## ADDENDUM

**PROJECT:** State of Nebraska  
Grand Island Veteran's Home  
WWII / Phillips Building  
Mechanical, Electrical, and ADA Upgrades  
Grand Island, Nebraska

AD-3

**DATE ISSUED:** Thursday, January 26, 2012

SHEET NUMBER  
**A-301**

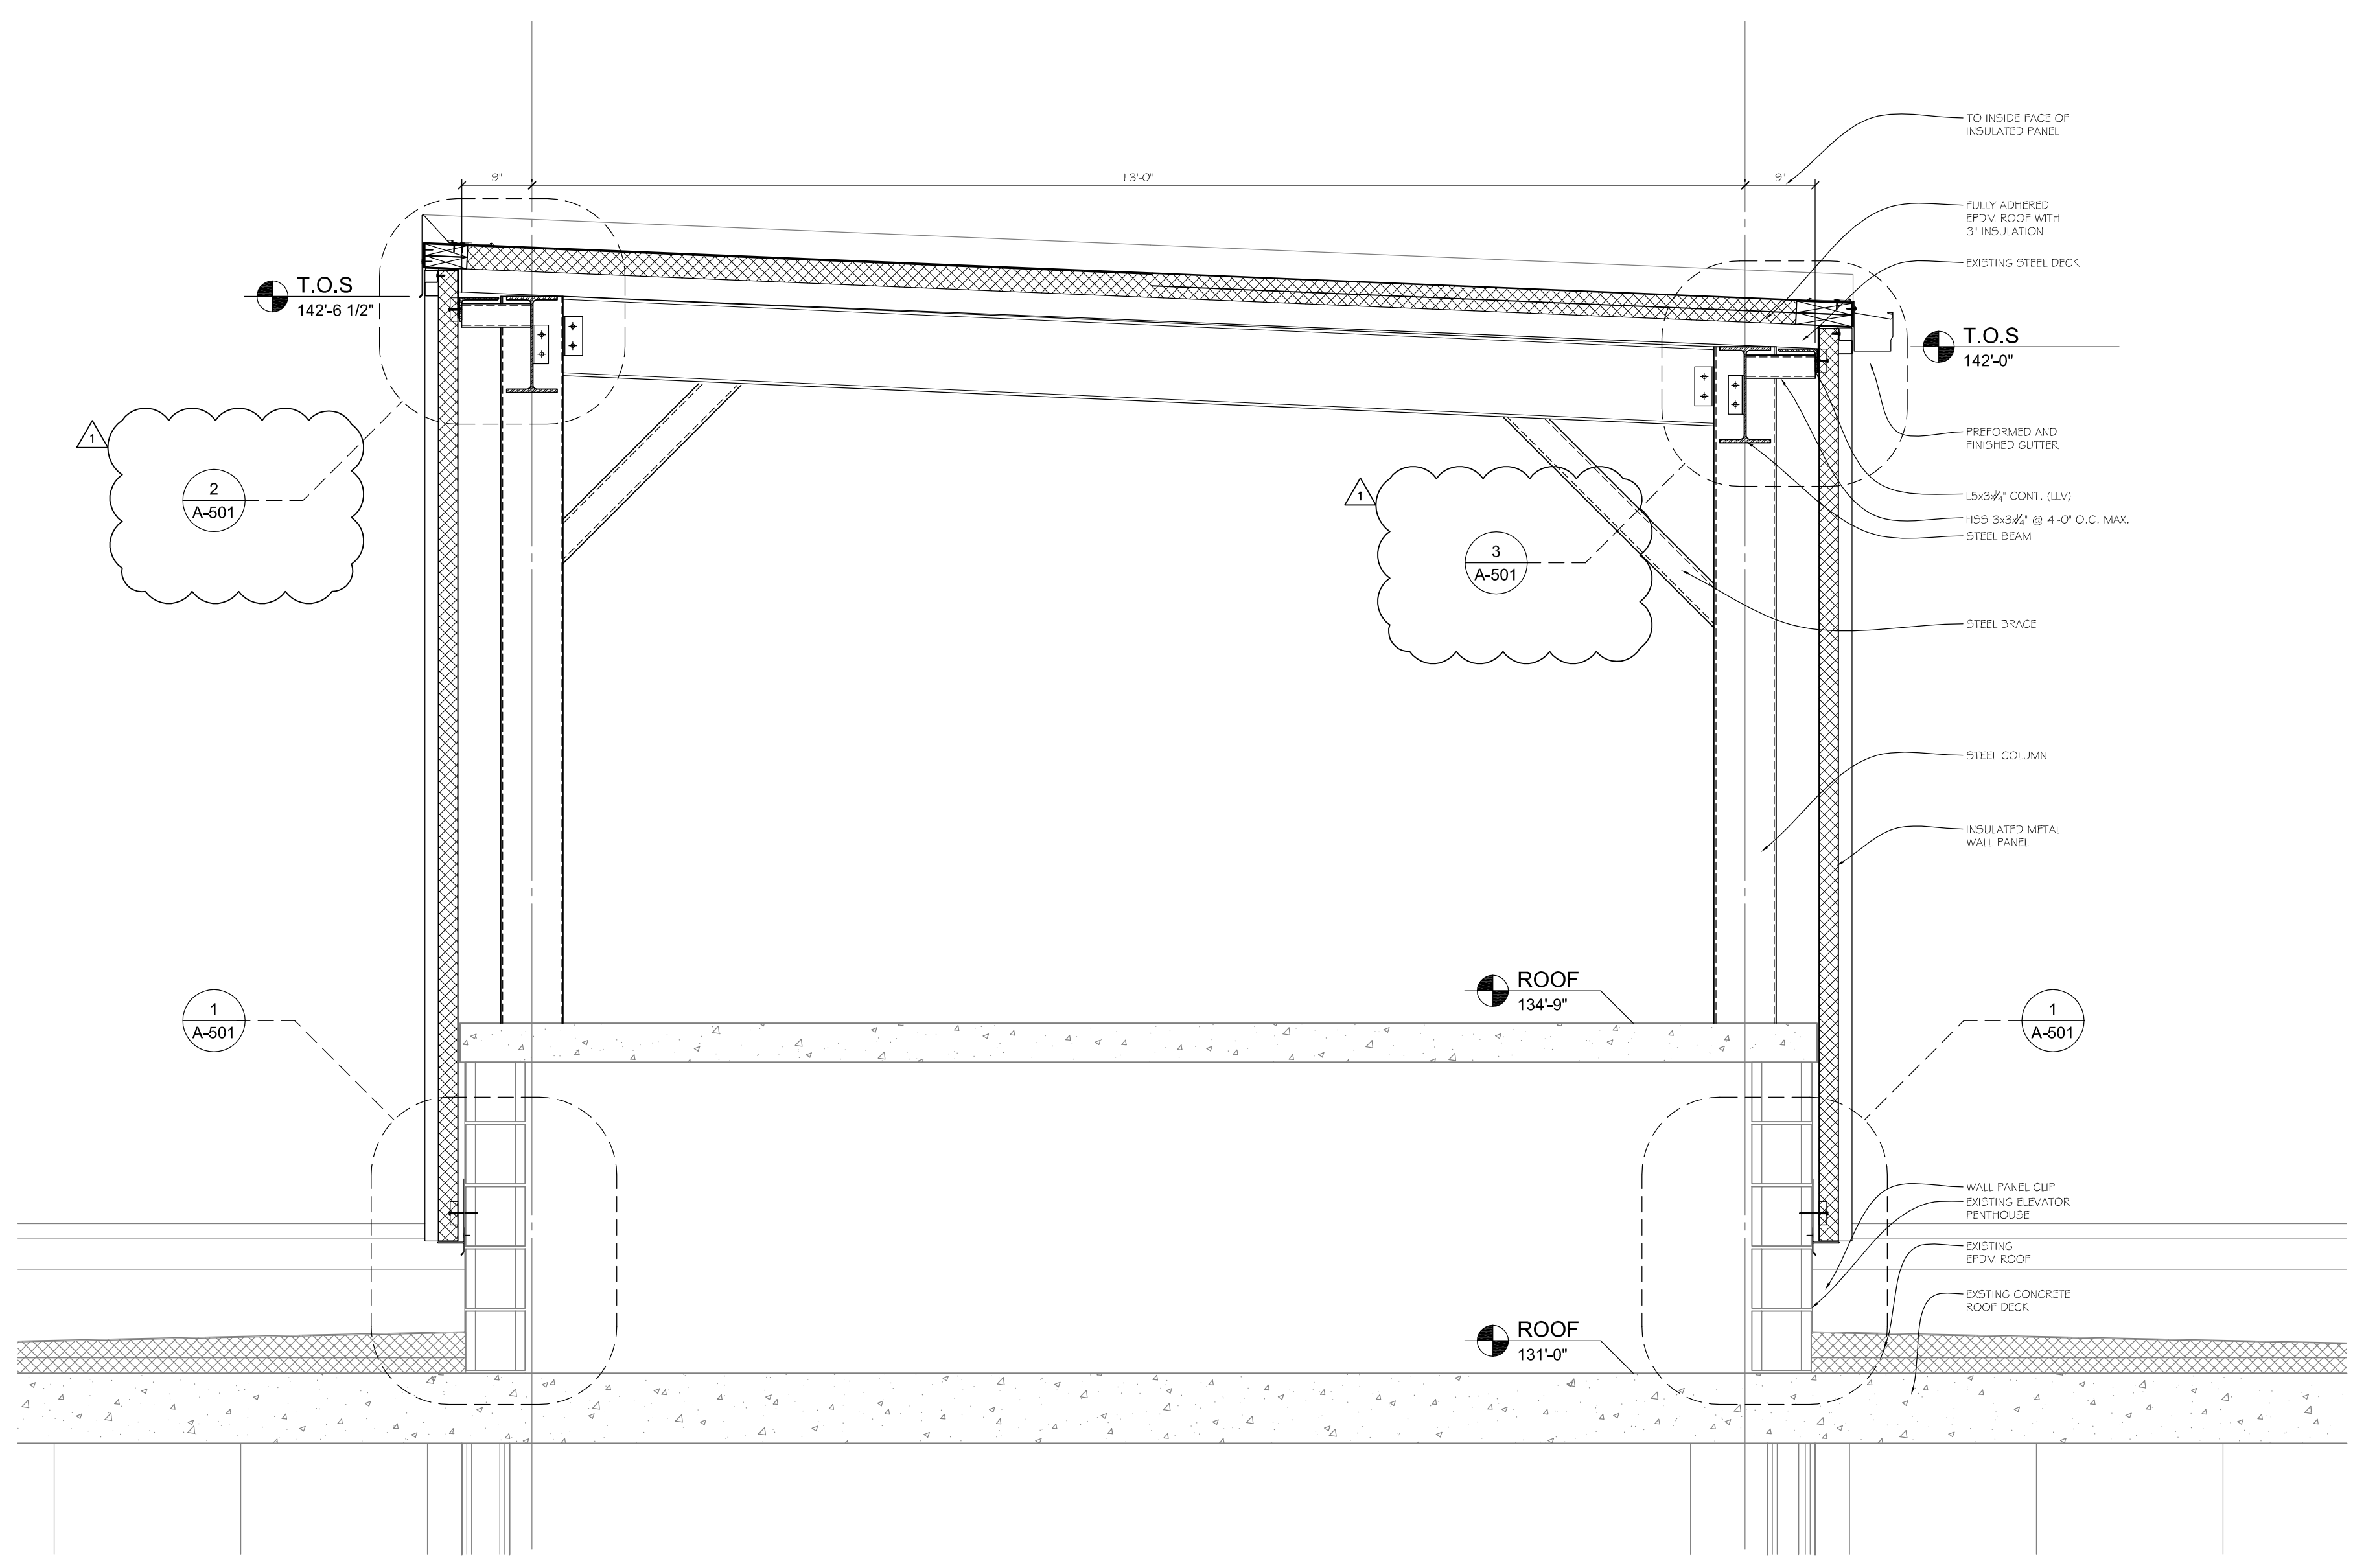
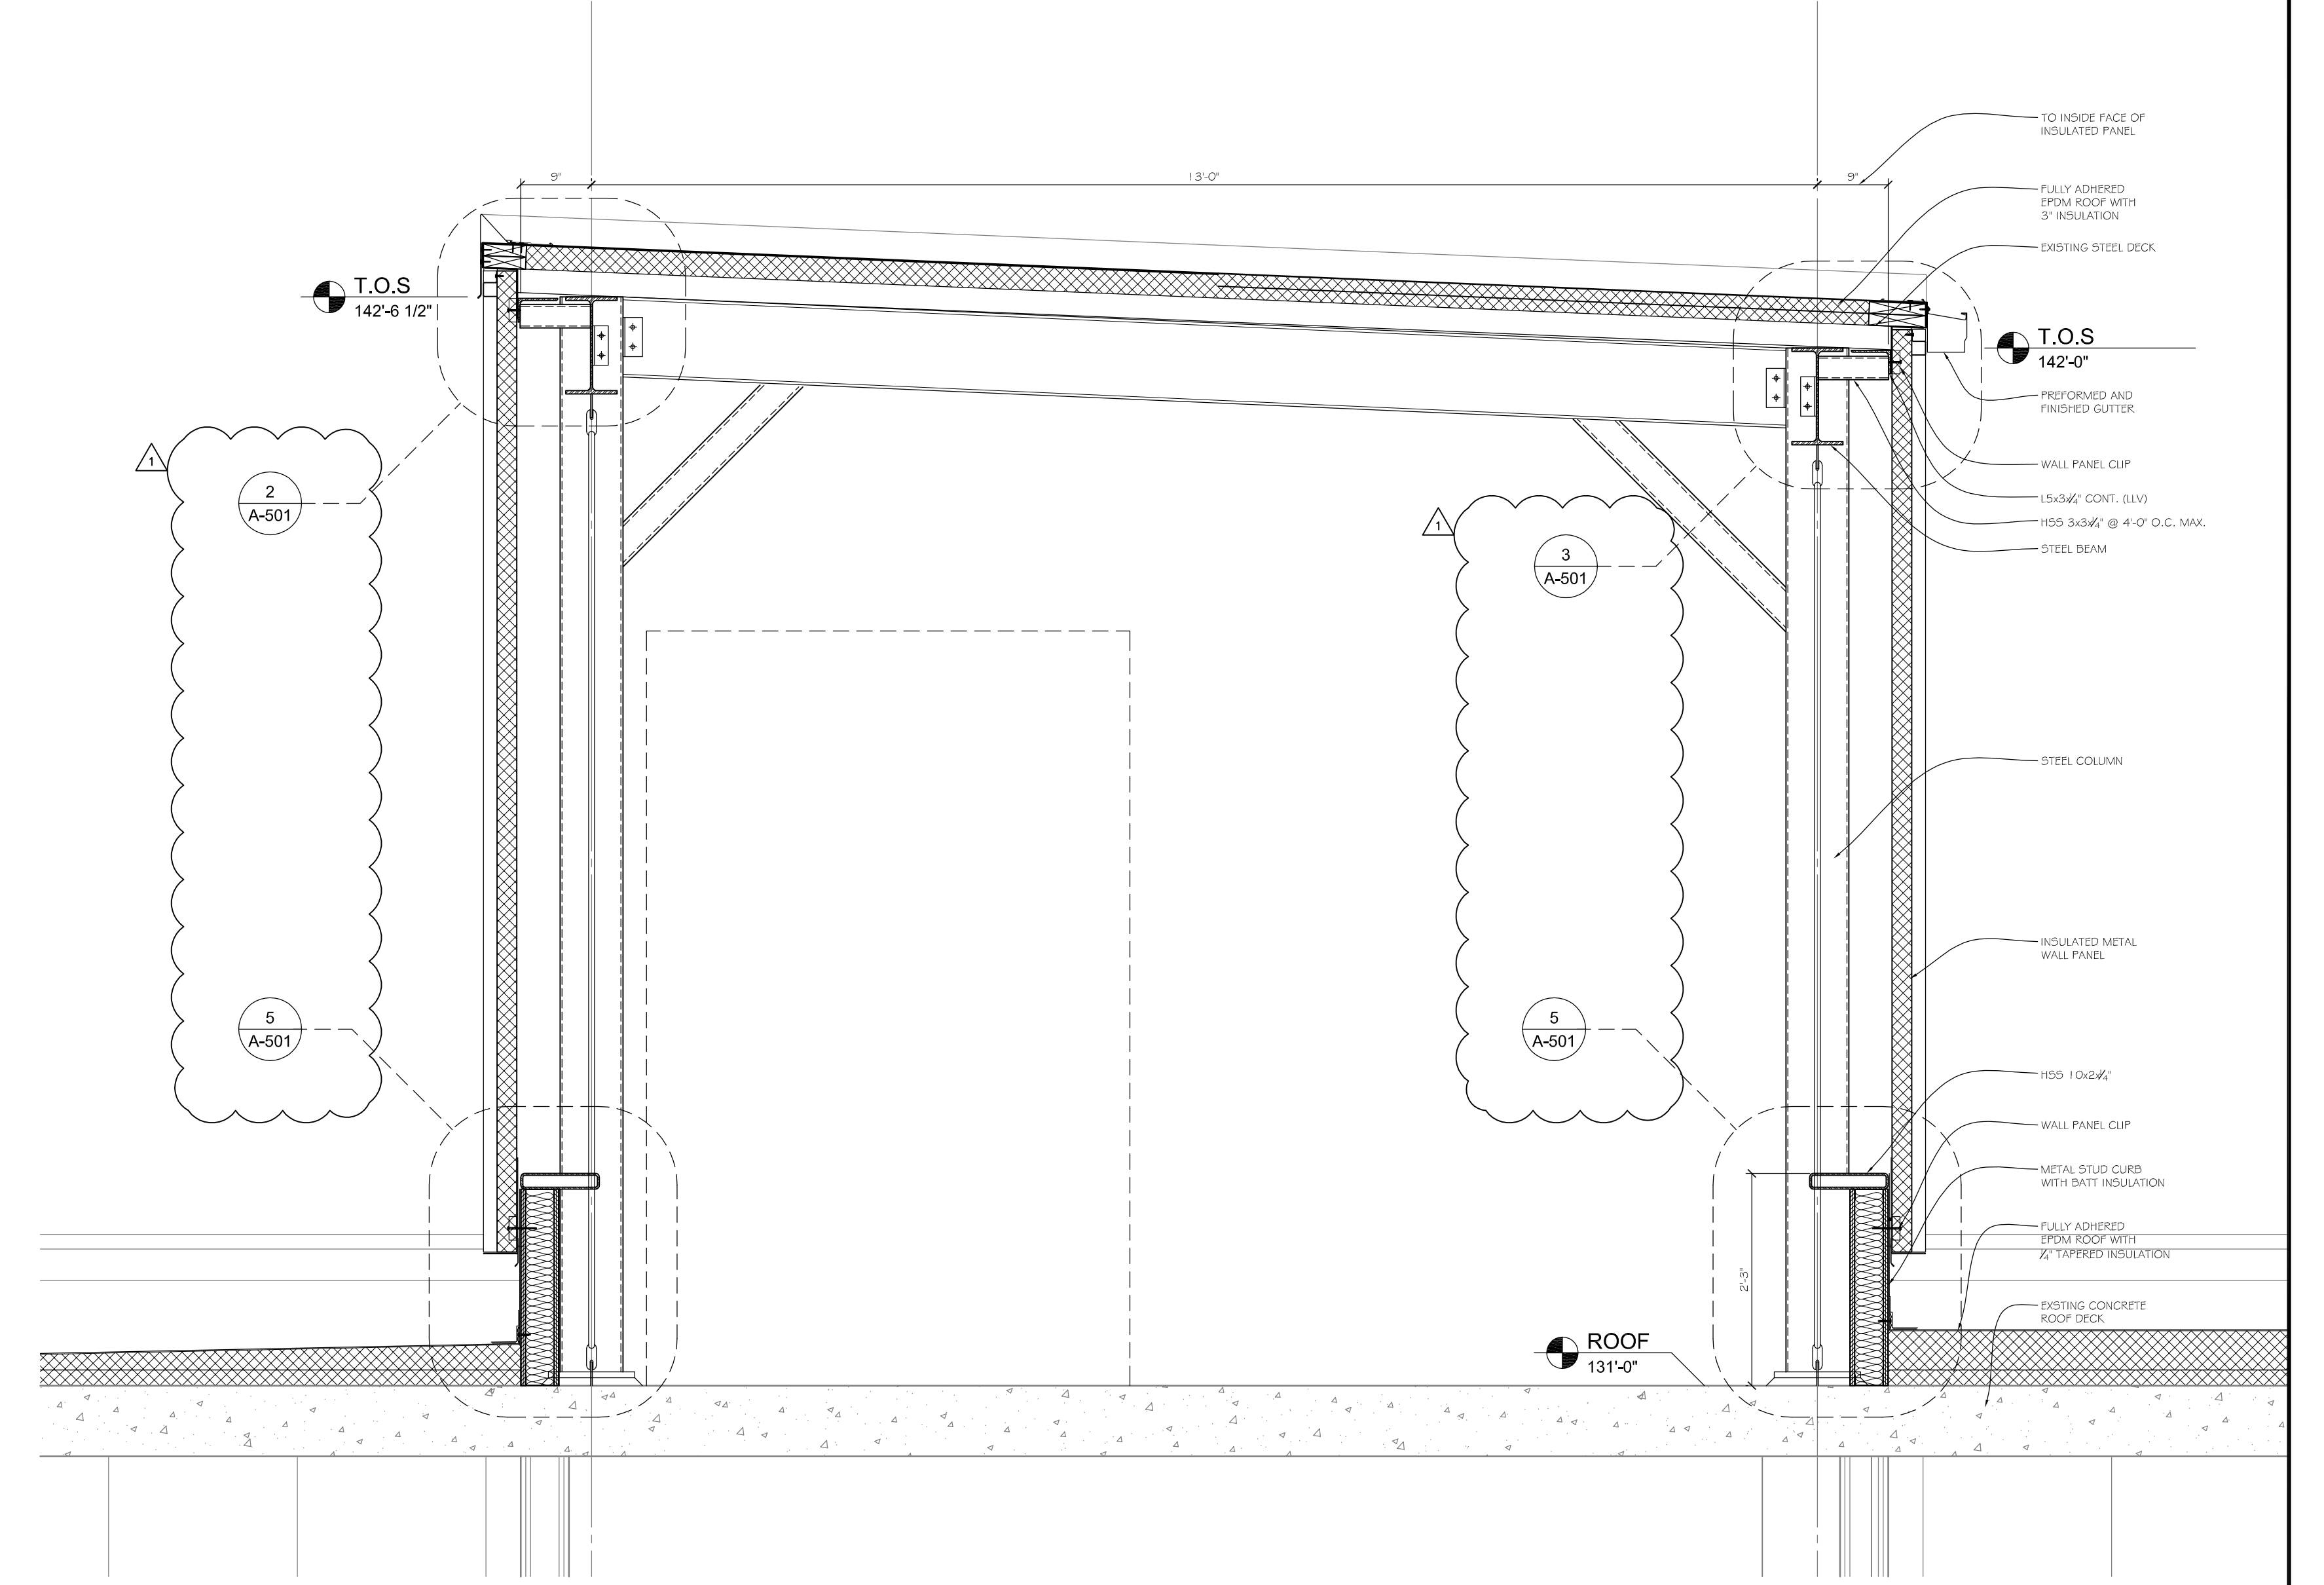
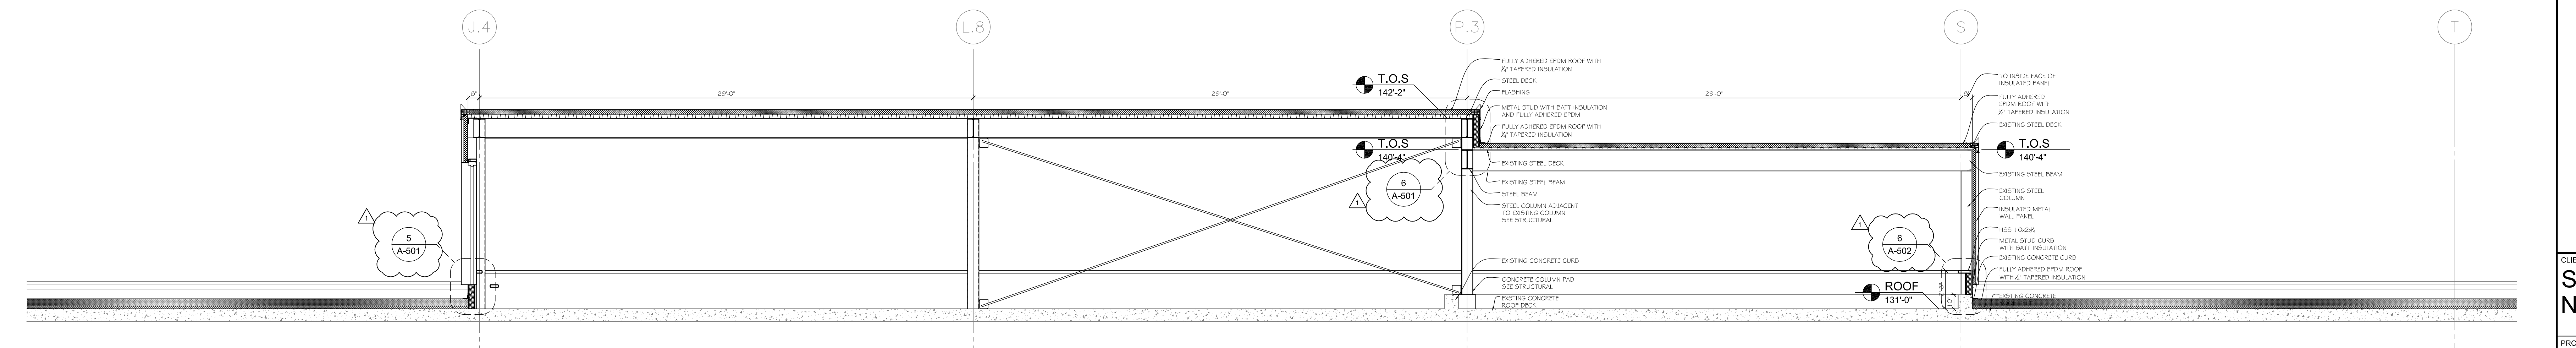
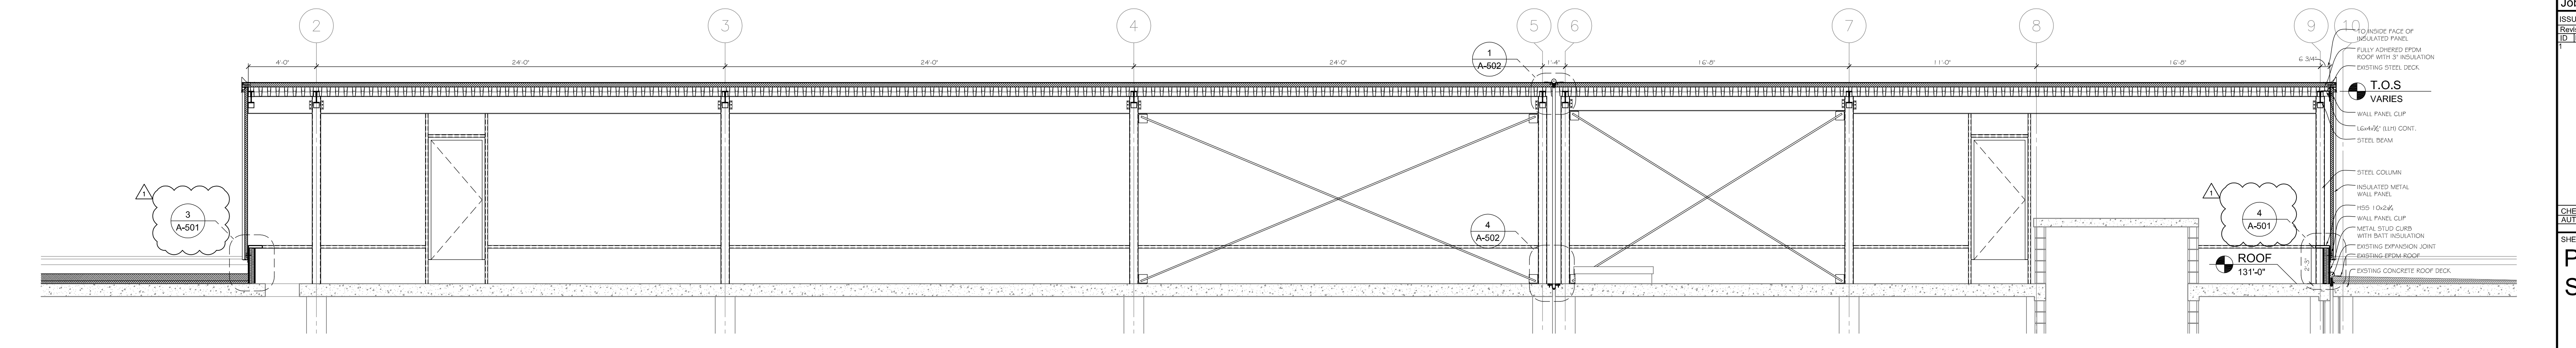
**In reference to drawing A-301 and A-302,** refer to attached drawings A-301 and A-302 for correct detail tags.

0125/12 Detail Tag Corrections AD-3
